Accredited Standards Committee  
NCITS, Information Technology

Doc.No. : T13/E01143R0  
Date : 12/3/2001  
Project : 1410D  
Ref. Docs. : T13/E01025R0  
Reply to : Mr. Peter McLean  
Maxtor Corporation  
2190 Miller Drive  
Longmont, CO 80501  
(303) 678-2149  
pete\_mclean@maxtor.com

To: T13 Membership  
From: Peter McLean, ATA/ATAPI-6 editor  
Subj: Response to ATA/ATAPI-6 letter ballot comments

The ATA/ATAPI-6 letter ballot, T13/E01025R0, project 1410D results were 18:0:0:2. In addition, two yes votes included comments.

Figure 29 – Host DMA state diagram

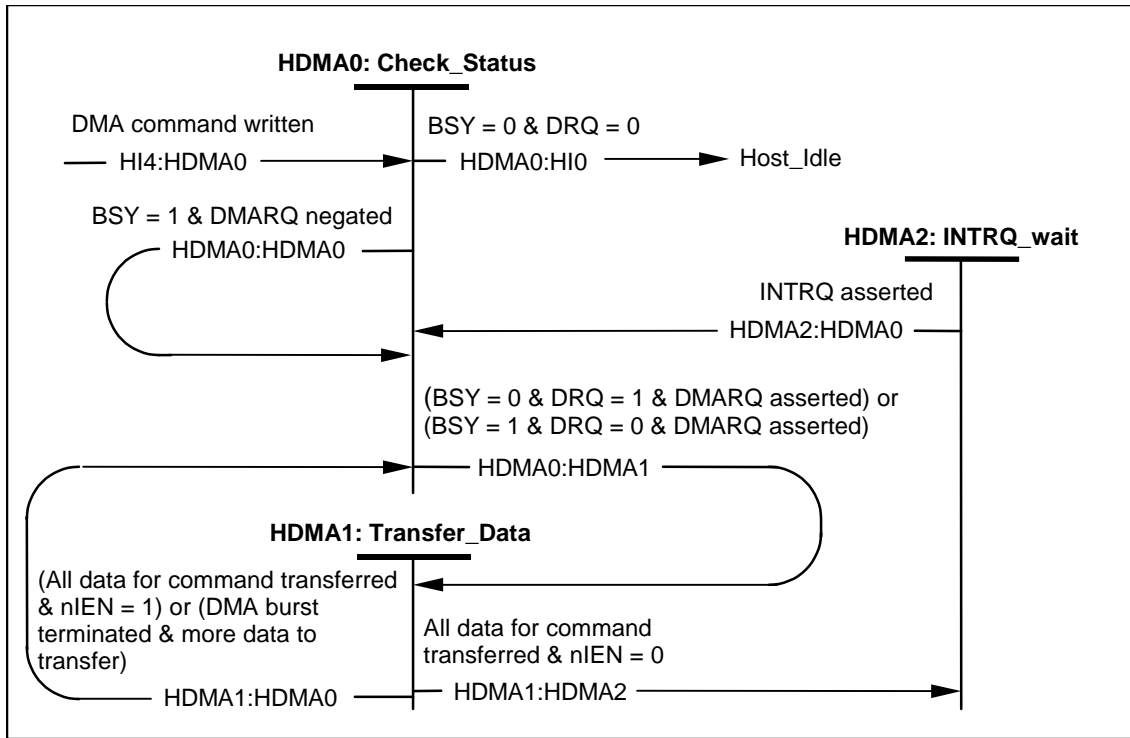
There is confusion as to whether or not all data must be transferred in a single DMARQ/DMACK assertion. To alleviate the confusion, it is proposed that figure 29, the text for the HDMA1 to HDMA0 transition, figure 30, and the text for the DDMA1 to DDMA0 transition be modified as shown.

**Transition HDMA1:HDMA0:** When the host has transferred all data for the command and nIEN is set to one or when the DMA burst has been terminated and all data for the command has not been transferred, then the host shall make a transition to the HDMA0: Check\_Status state.

**Comment accepted**

Figure 33 – Host PACKET DMA command state diagram

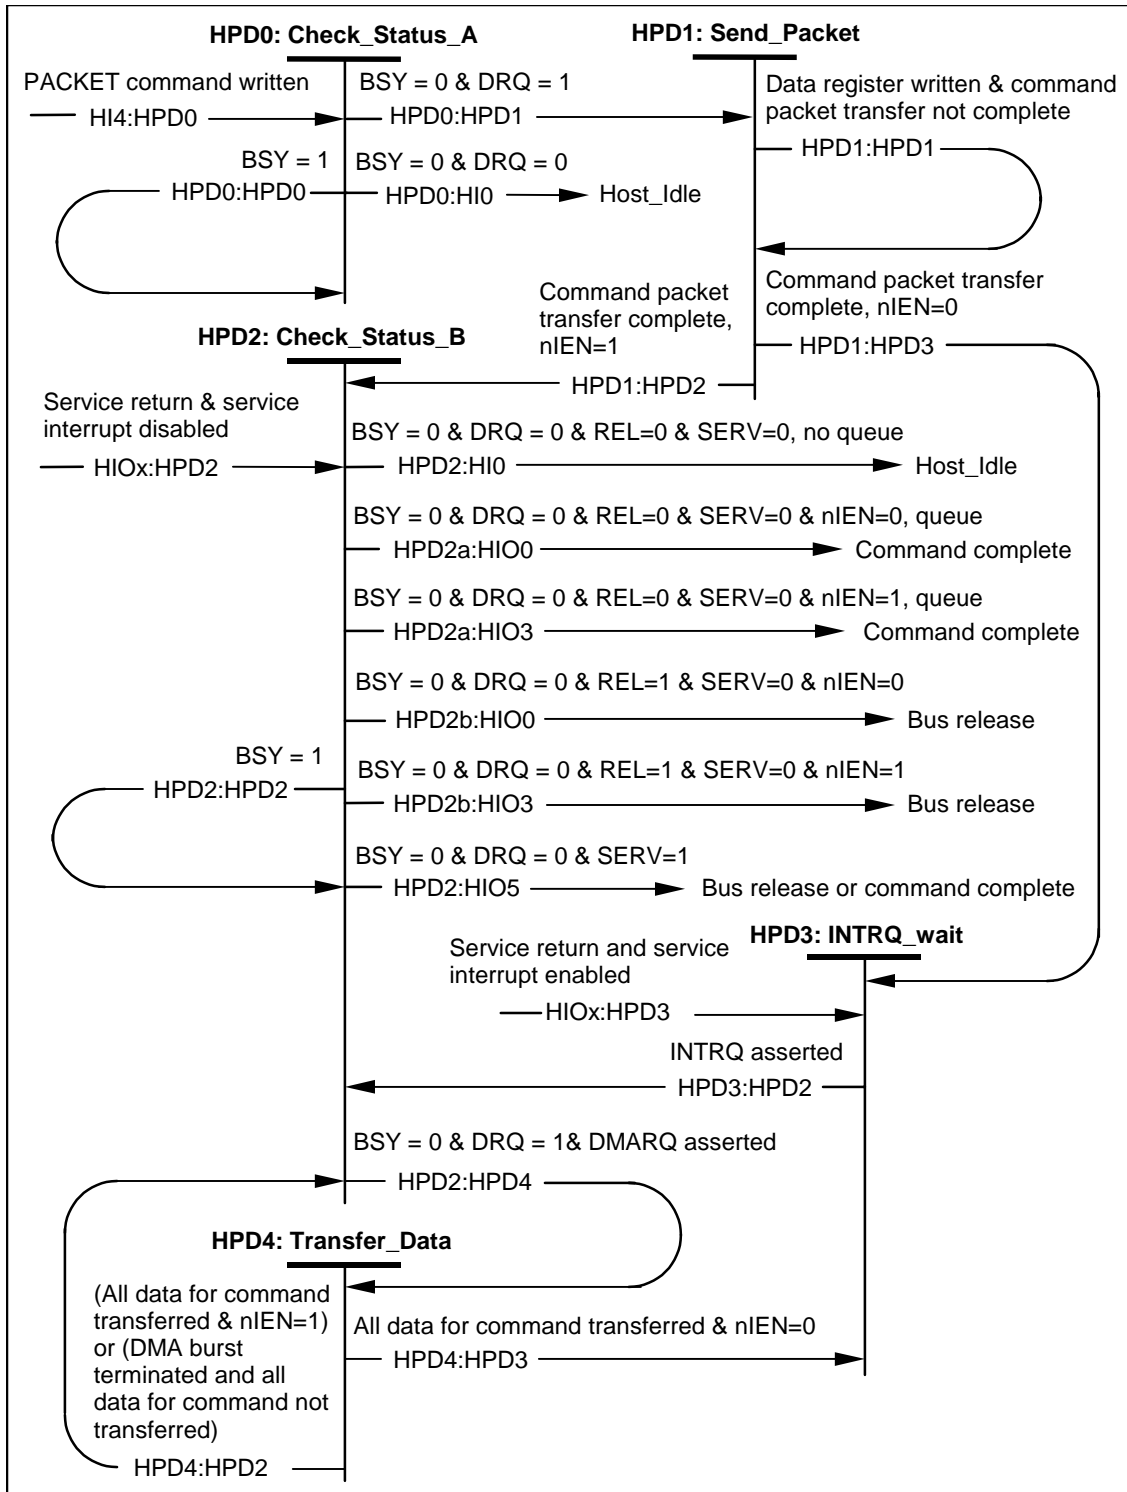
There is confusion as to whether or not all DMA data must be transferred in a single DMARQ/DMACK assertion. To alleviate the confusion, it is proposed that figure 33, the HPD4 to HPD2 transition, figure 34, and the text for the DPD4 to DPD2 transition be modified as shown.

**Transition HPD4:HPD2:** When the host has transferred all data for the command and nIEN is set to one or when the DMA burst has been terminated and all data for the command has not been transferred, then the host shall make a transition to the HPD2: Check\_Status\_B state.

**Comment accepted**

**Figure 35 – Host DMA QUEUED state diagram**

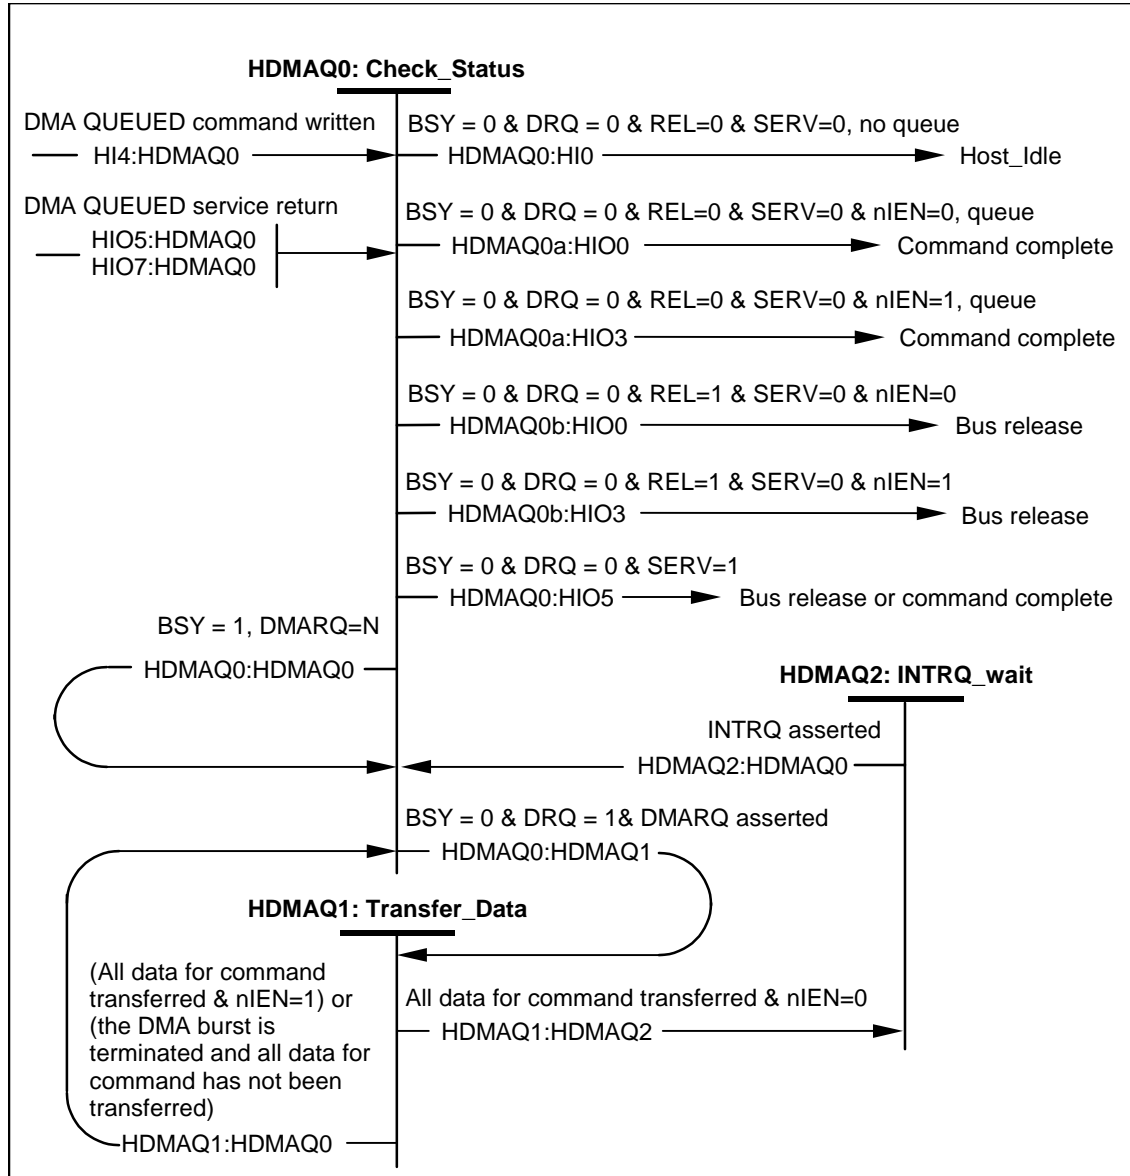
There is confusion as to whether or not all DMA data must be transferred in a single DMARQ/DMACK assertion. To alleviate the confusion, it is proposed that figure 35, the HDMAQ1 to HDMAQ0 transition, figure 36, and the text for the DDMAQ1 to DDMAQ0 transition be modified as shown.

**Transition HDMAQ1:HDMAQ0:** When all data for the request has been transferred and nIEN is set to one or when the DMA burst is terminated and all data for the request has not been transferred, then the host shall make a transition to the HDMAQ0: Check\_Status state.

**Comment accepted**
